AGENDA

DEVELOPMENT DETERMINATION PANEL MEETING

WEDNESDAY 26 AUGUST 2020

ITEM 3.1	DA2020/0559 - 16 NAREE ROAD, FRENCHS FOREST - DEMOLITION WORKS AND CONSTRUCTION OF A BOARDING HOUSE
REPORTING MANAGER	Rodney Piggott
TRIM FILE REF	2020/480557
ATTACHMENTS	1 Assessment Report 2 Site Plan & Elevations

Figure 1: Northern elevation wall height non-compliance shown in green.

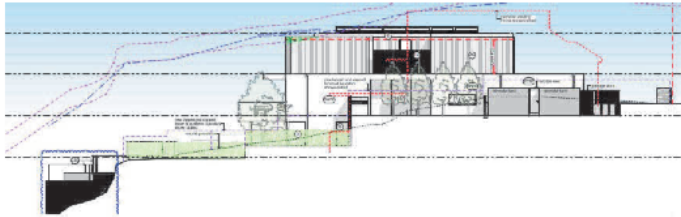
The wall height on the northern elevation is 3.1m to a maximum of 7.6m, which represents a variation of 0.4m (5.5%), as demonstrated in Figure 1 below.

Figure 3: Southern elevation building envelope non-compliance shown in green.

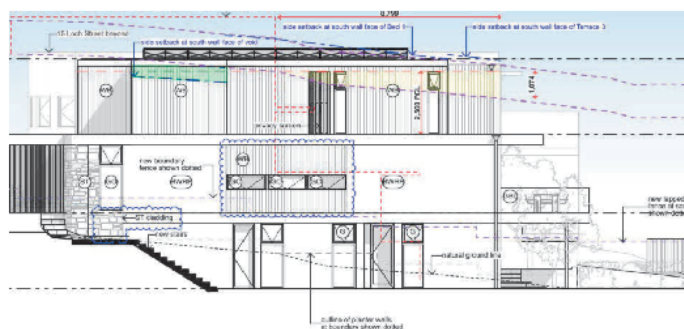
The non-compliant areas occur along the top edge of the southern elevation (area adjoining the stairs/void area).

The figure below indicates (in green) the area of non-compliance.

Figure 4: Non-compliance area within the rear setback shown in green.

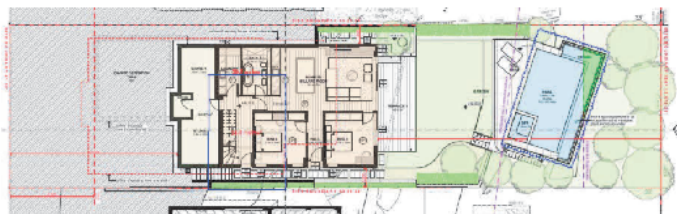
The proposed swimming pool is located 4.4m - 7.1m from the rear boundary, thereby contravening the minimum 6m setback requirement.

However, in accordance with the exceptions provision, swimming pools may encroach the rear setback area provided the area of the pool does not exceed 50% of the setback area provided that the objectives of this provision are met. In this instance, the pool encroaches a very minor area of 4.9sqm of the approximately 52.8sqm rear setback area, see figure 4 below.

Figure 4 - Elevation of proposed dwelling with finished level of Lolita Avenue shown as red line.

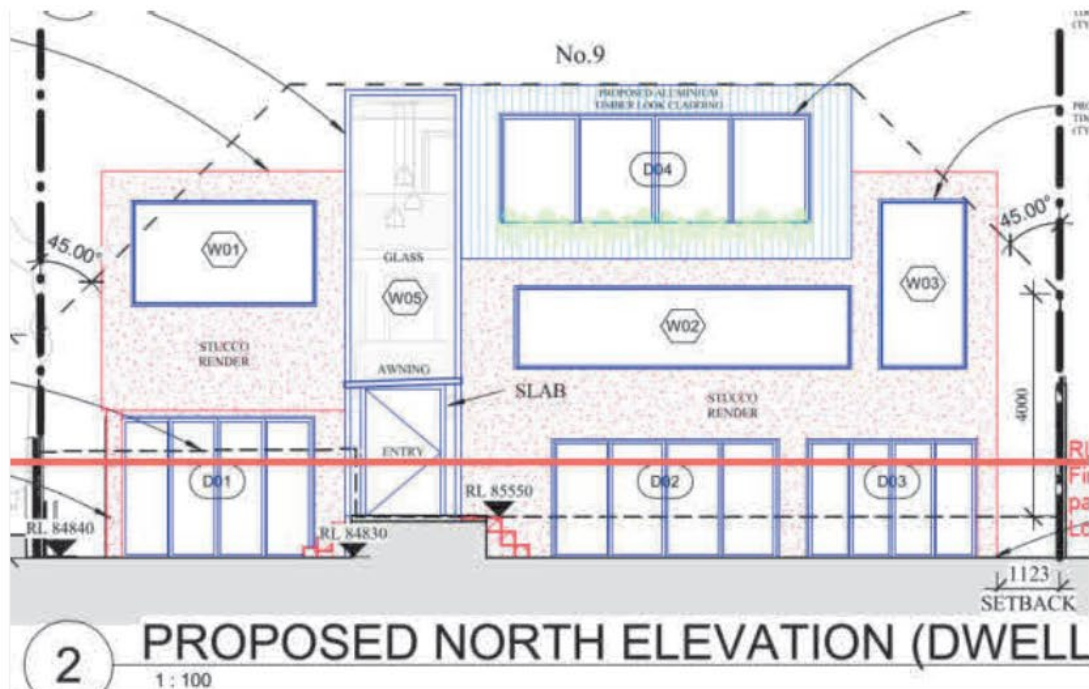
The proposed additions are considered to remain compatible with surrounding development. While the development is not replicating or necessary mimicking the style of the surrounding properties, the overall height when viewed from the street will be commensurate. The finished height of the new 'second floor level' is 1.43m higher than the existing ridge line and does not extend the full width of the house as the existing roof line does.

Figure 2 - The existing and proposed frontage of the development

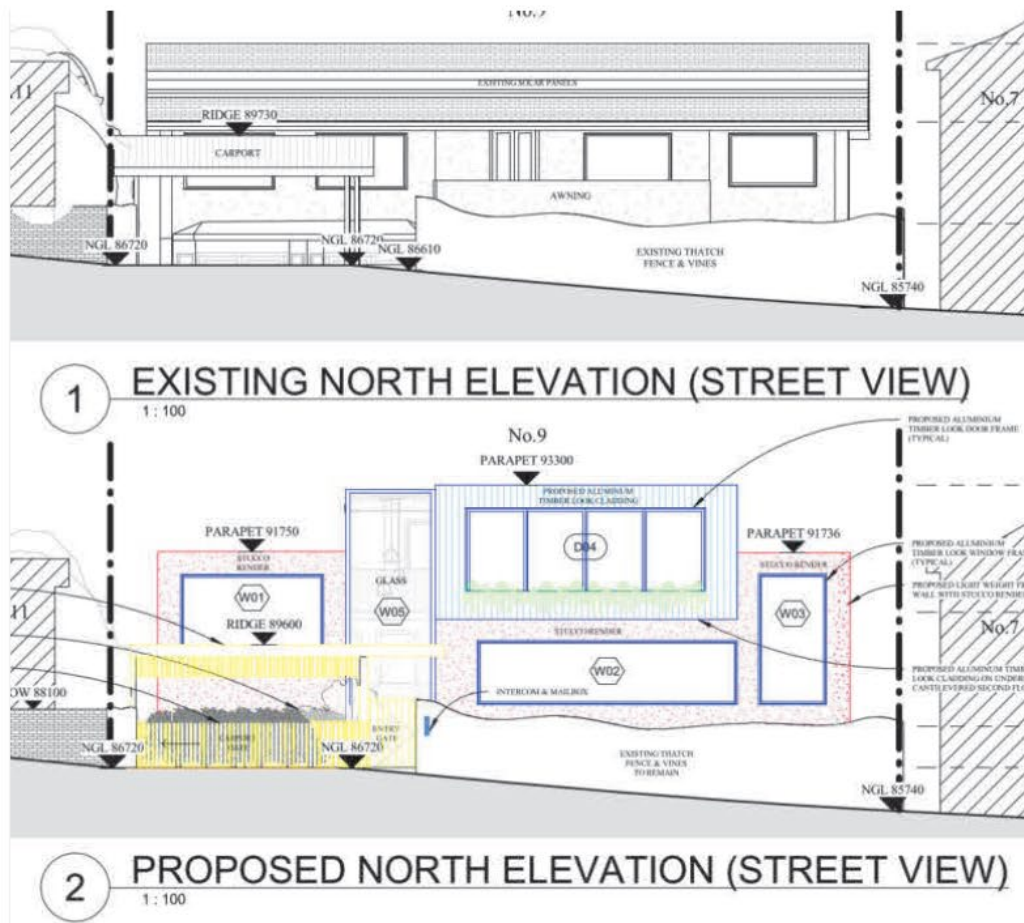
The site is currently developed and the frontage contains a swimming pool and the carport structure. The proposed carport is in essentially the same location maintains sight lines through the front of the site to the dwelling and is considered to satisfy this requirement.

Figure 3 - Excerpt from Proposed Site Plan (source: Architectural Plans by Dellview Designs)

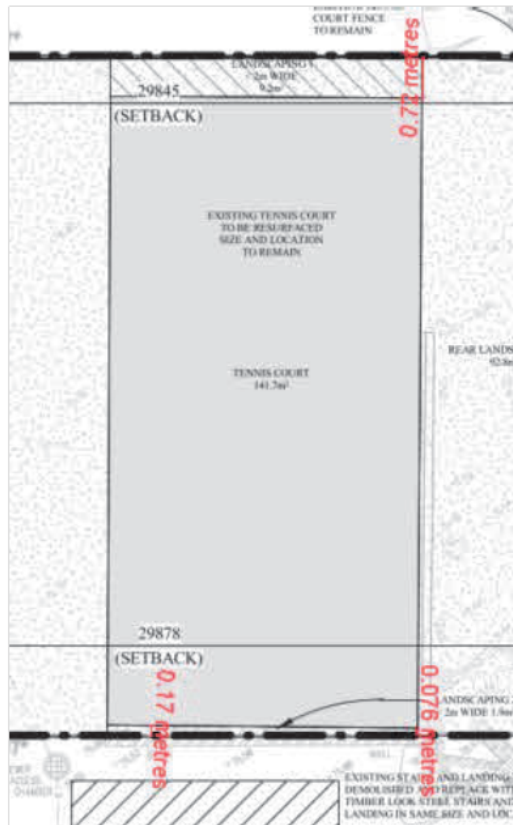
The site currently contains an unauthorised tennis court which is in a poor state of repair, has insufficient fencing and has unauthorised artificial illumination. The proposed development seeks consent for a tennis court (resurfaced) in the same position as the existing one. Due to the orientation and proportions of the site, the tennis court cannot comply with the requirement to provide a 1.5m setback from the side boundaries. The plans indicate a 0.7m setback to the west and an approximate

0.1m setback to the east where the tennis court aligns with the neighbouring cabana.
